# Hood Layout for Grinder

Project:	Accellent
Drawing:	Hood detail
Date:	4/2/11
Drawn by:	RAV
Sheet No:

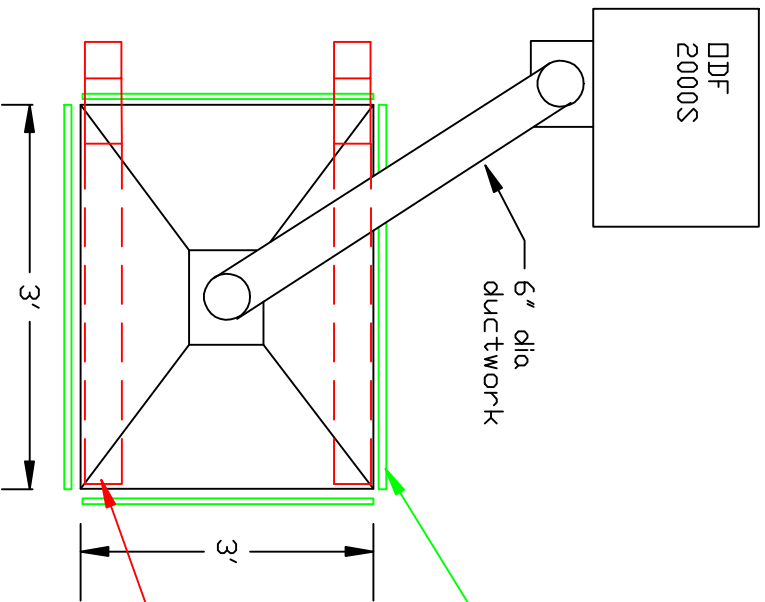
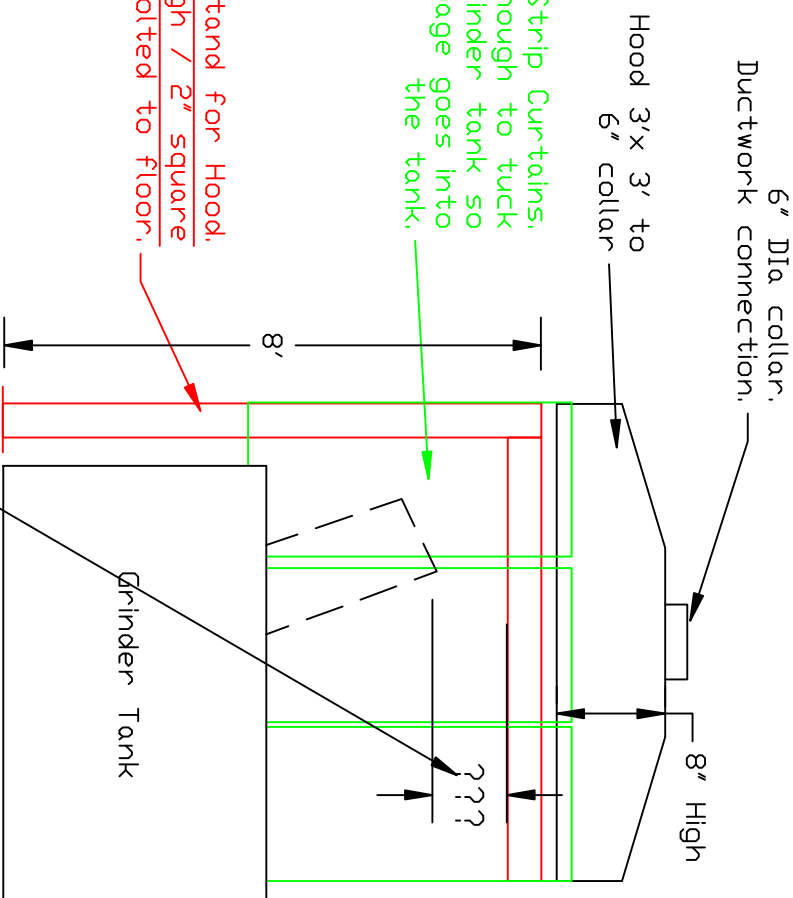
What is the distance needed to clear the motor and be able to service it?
